# Access Compliance Report

## Public Rights-of-Way

| Intersection ID: 46949                  | Main Street: PROVIDENCE LN WEST | Cross Street: MADISON OAKS CT           | Location: SW           |
| ADA ID: 91C4D21D1122                    | Ramp Type: PerpDiag             | Initial Pass/Fail: Fail                 | Overall Compliance: No |

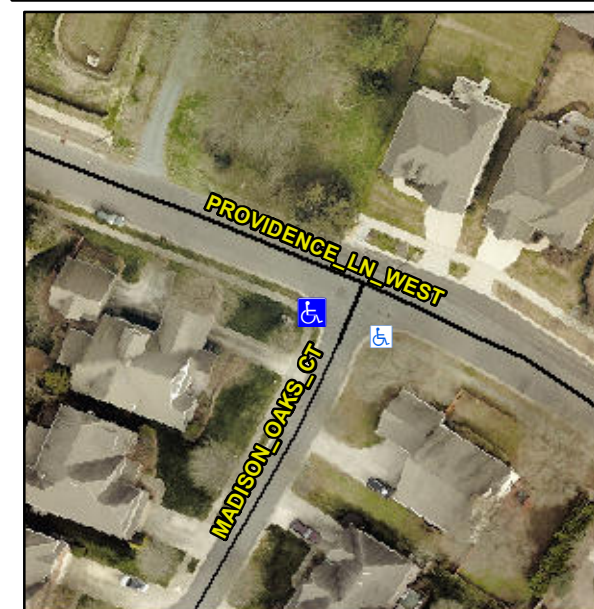
**R304.2.2, R304.5.3**

| Compliance | Description           | Data  | Compliance | Description                 | Data  |
|------------|-----------------------|-------|------------|-----------------------------|-------|
| N/A        | Ramp Length (in)      | 96.0  | No         | Ramp Slope (%)              | 8.7   |
| Yes        | Ramp Width (in)       | 48.0  | No         | Ramp XSlope (%)             | 3.0   |

**Remove & Replace Curb Ramp With Two New Directional Ramps or Equivalent.**
